# KITTERY TOWN PLANNING BOARD MEETING

**AGENDA for Thursday, November 13, 2014**

**Town of Kittery Maine  
 Town Planning Board Meeting  
 November 13, 2014**

**84 Pepperrell Road – Shoreland Development Plan - Public Hearing.** Action: Hold public hearing, review, and approve or deny plan approval. 84 Pepperrell LLC, owner, and Jonathan MacDougall, applicant, requests approval to add a 73 sf patio to an existing accessory building at 84 Pepperrell Road, Tax Map 27, Lot 51, in the Kittery Point Village/Business Local and Shoreland Overlay Zones.

**STANDARD BOUNDARY SURVEY**  
FOR PROPERTY AT  
**62 Pepperell Road**  
Kittery Point, York County, Maine  
OWNED BY  
**PEPPERELLCOVE LLC**  
6 Starboard Lane, York, Me 03909

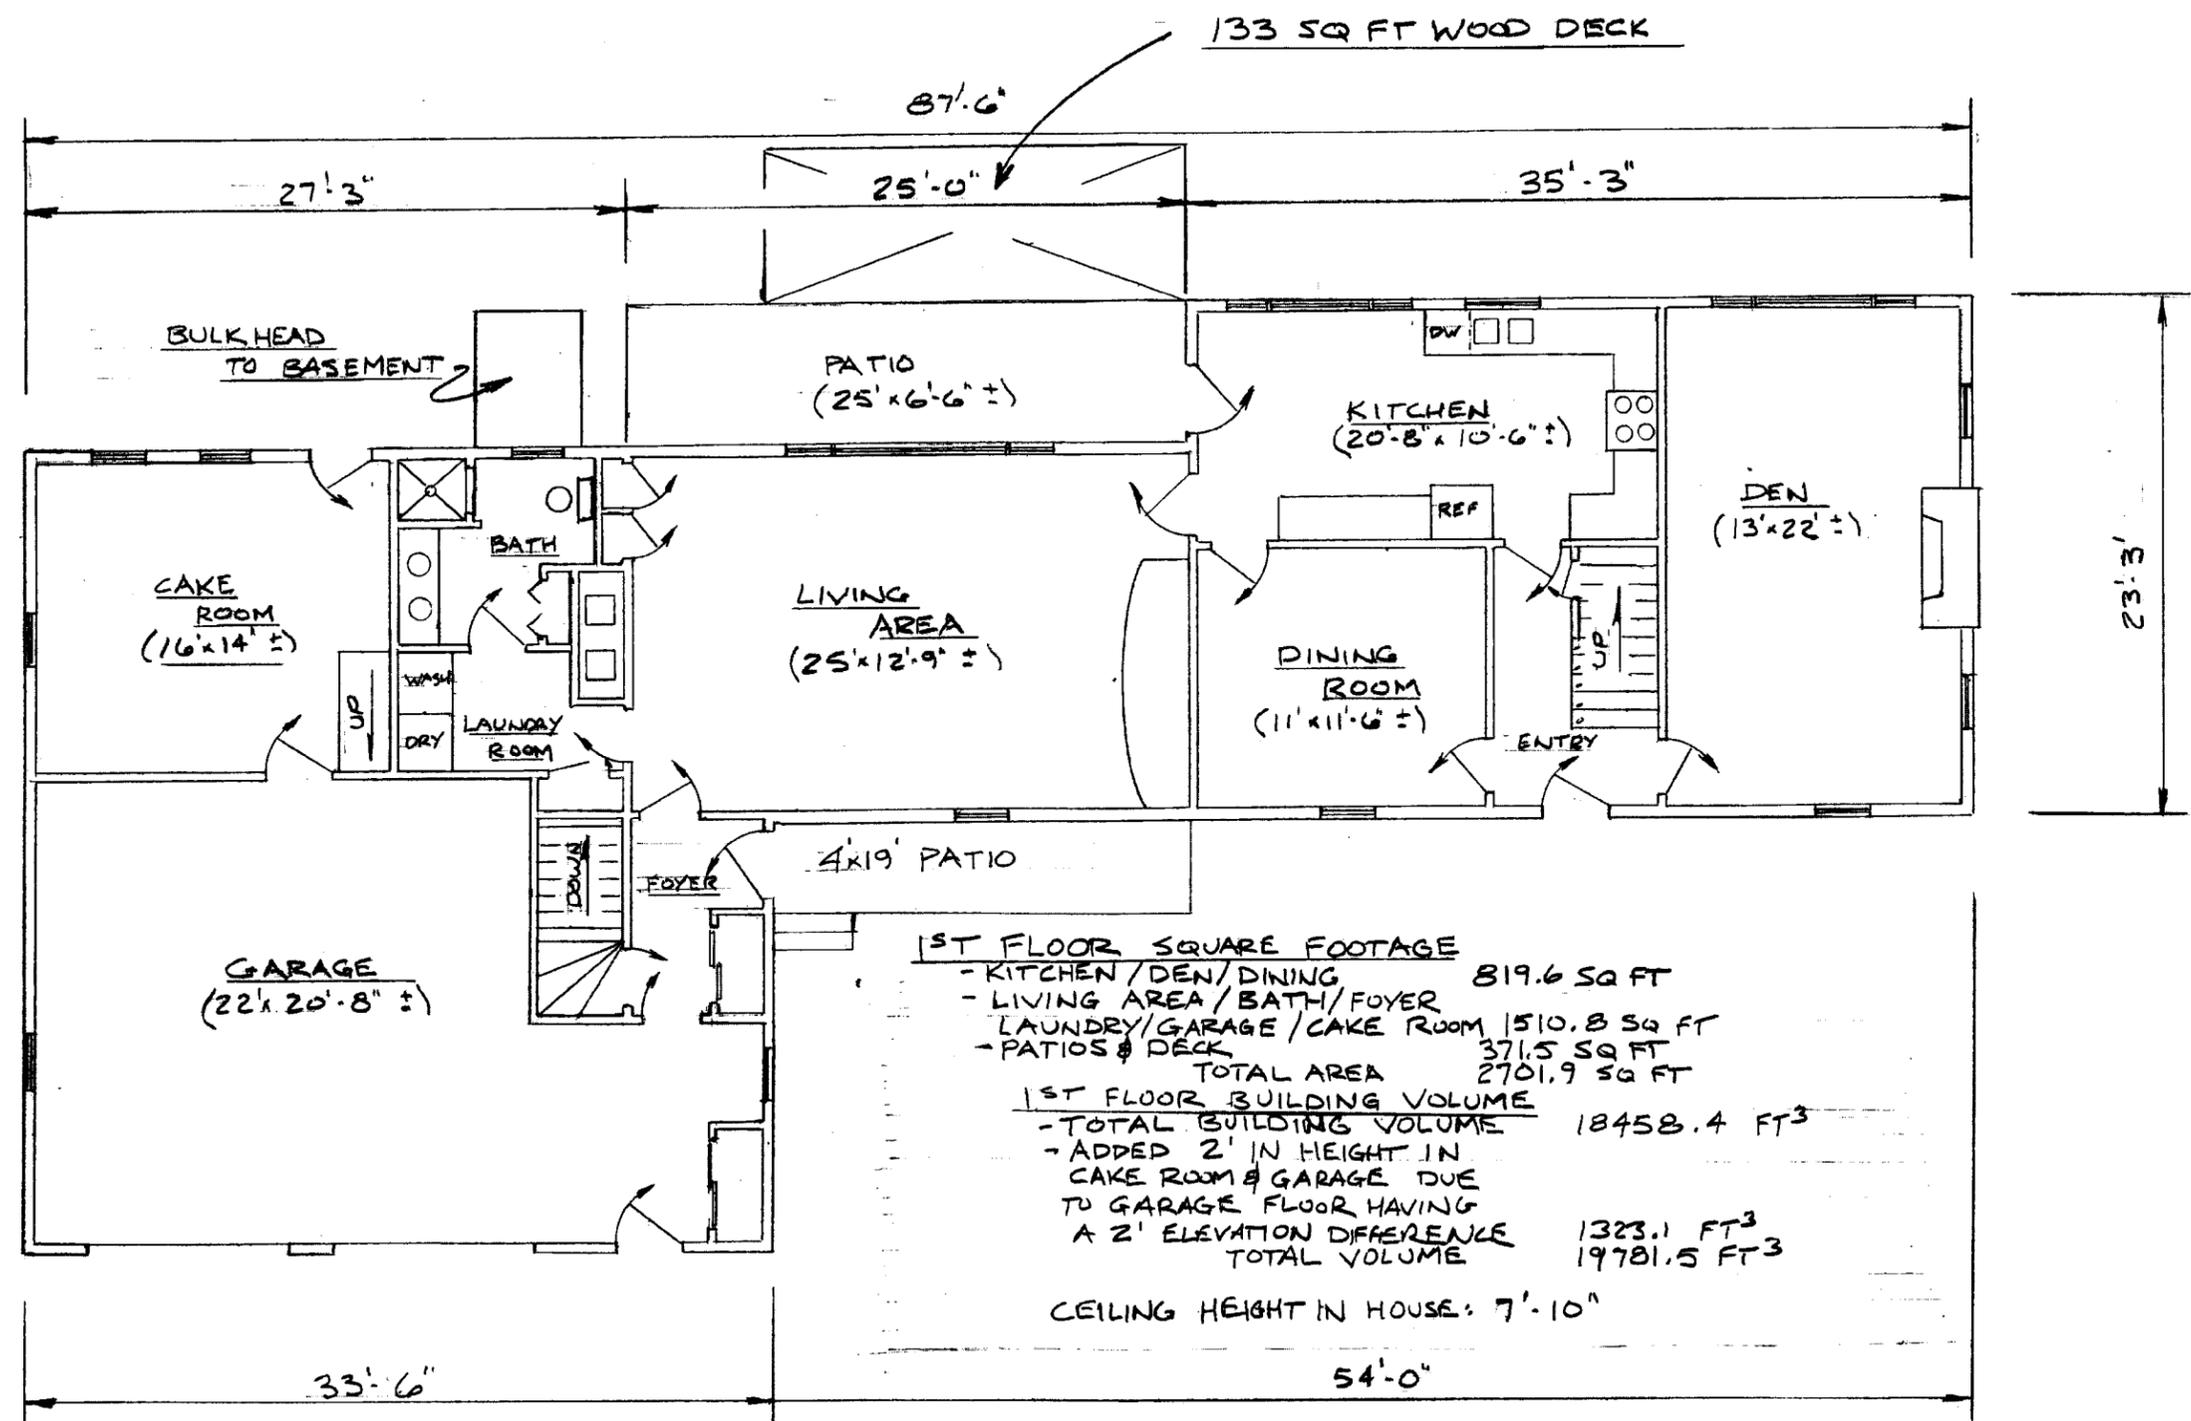
The applicant has provided the volume, area, and impervious coverage calculations on the updated Standard Boundary Survey (dated 3/26/13 as revised) as requested.

Plan should be entitled, *Shoreland Development Plan*, replacing "Standard Boundary Survey". Approval block needs to be amended as follows:

DRAWN BY: \_\_\_\_\_ RMB  
APPROVED BY: \_\_\_\_\_ JKC  
DRAWING FILE: 4567CONCEPT2.DWG  
SCALE: 1" = 100'

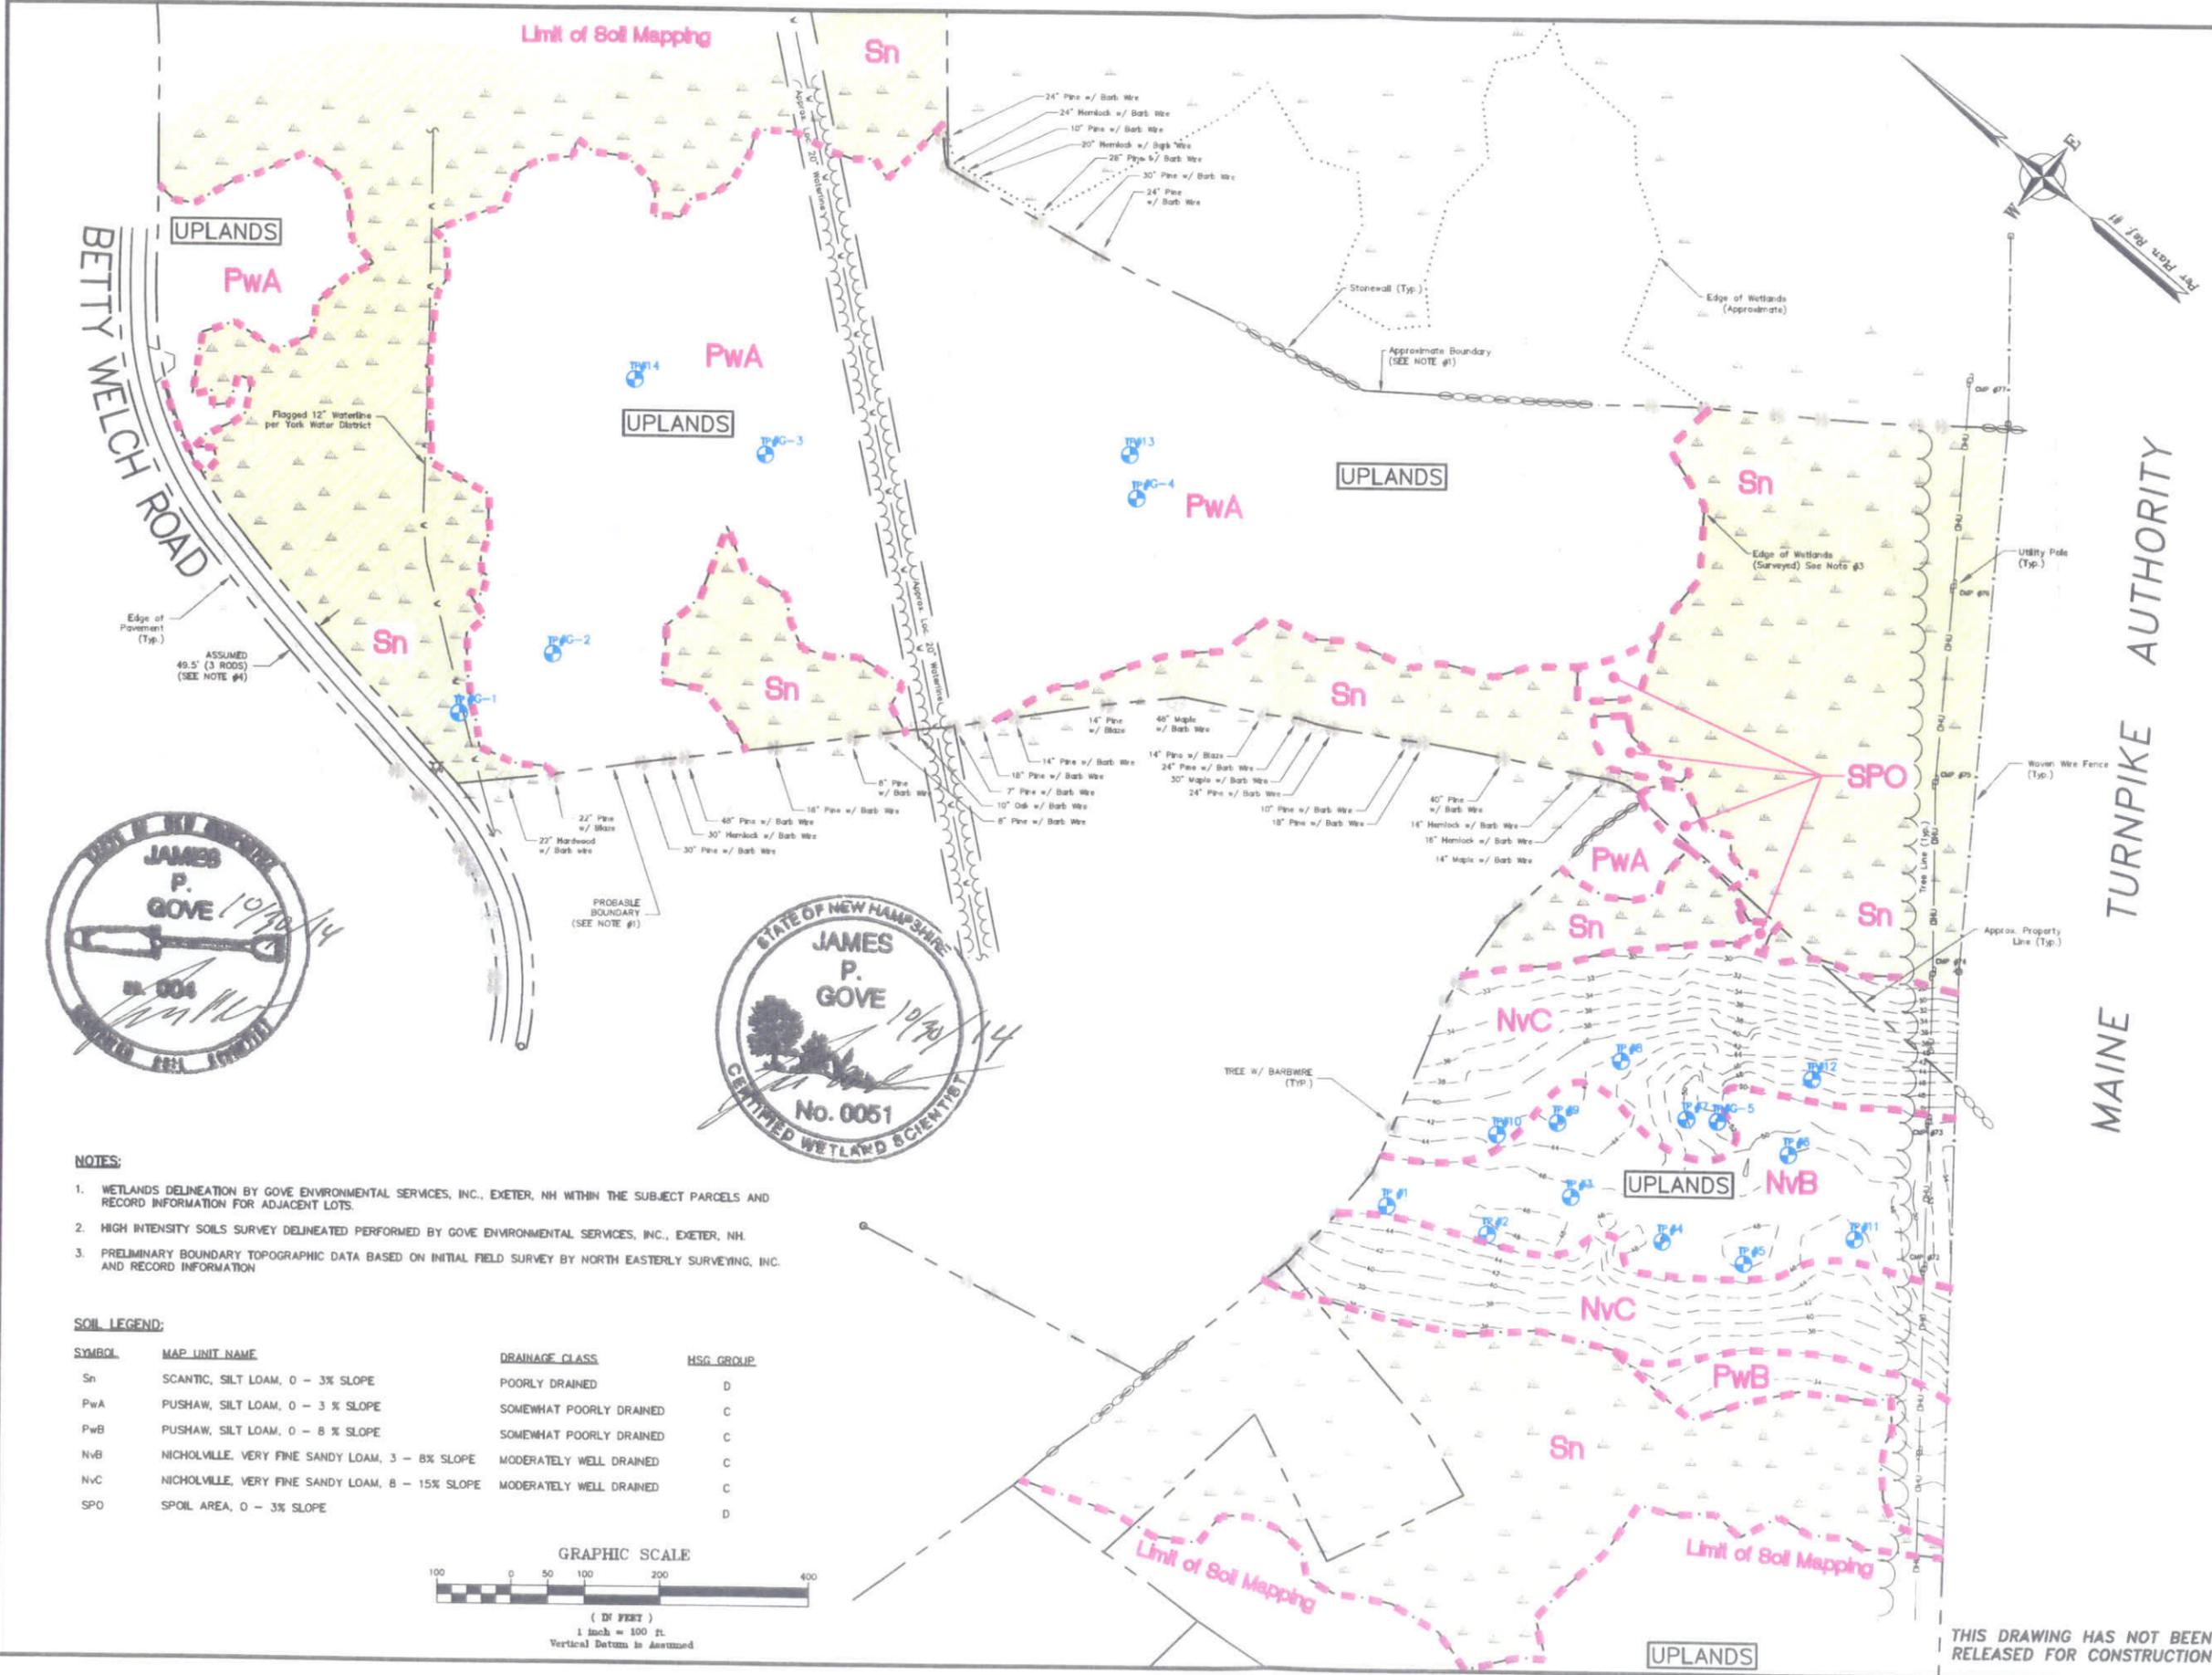
- A.1.a Dimensional standards and identified areas for modification included (Sheet CC-3). Exact modification requests should be submitted at Preliminary Plan Completeness Review.

- A.1.c Calculations for net residential acreage and density included on Sheet CC-3.
- A.1.d Sheet CC-3: Open space of 50% minimum appears to have been met. Upland open space of 30% of net residential acreage (25 acres), totals 7.5 acres (calculation on Sheet CC-3 indicates 7.2 acres based on 24 acres). It is unclear from the Zoning Summary on the Sheet CC-3 how the 'Total Uplands Area' is derived. Staff spoke to the Jeff Clifford with Altus Engineering and obtained clarification of the information depicted on the plan. Since all of the wetlands have not been delineated and soils report not finalized, the upland area that has been delineated, as depicted in dark green, including the area with the proposed lots and street, is used as a starting point. The expectation is to have the soils information and a more refined upland area number before the Board grants approval of the sketch plan.

2. Constraints to development: Plan Sheets CC-2 (Existing Conditions) and CC-3 (Concept Plan) identify wetlands, existing utilities (Kittery Water District easement), wetland protection areas, and wetlands setbacks. Beginning with Habitat map identifies the site location, and applicant will seek habitat determination from the Department of Inland Fisheries and Wildlife. There are no existing driveways, structures, etc. identified on the site.
3. Project Narrative is provided. Further review is needed to determine whether cluster objectives have been satisfactorily met, including road length/width, wetlands mitigation, identification of existing natural features/sites, habitat, etc.
4. Proposed building envelopes provided (Sheet CC-3). Lot dimensions not included.
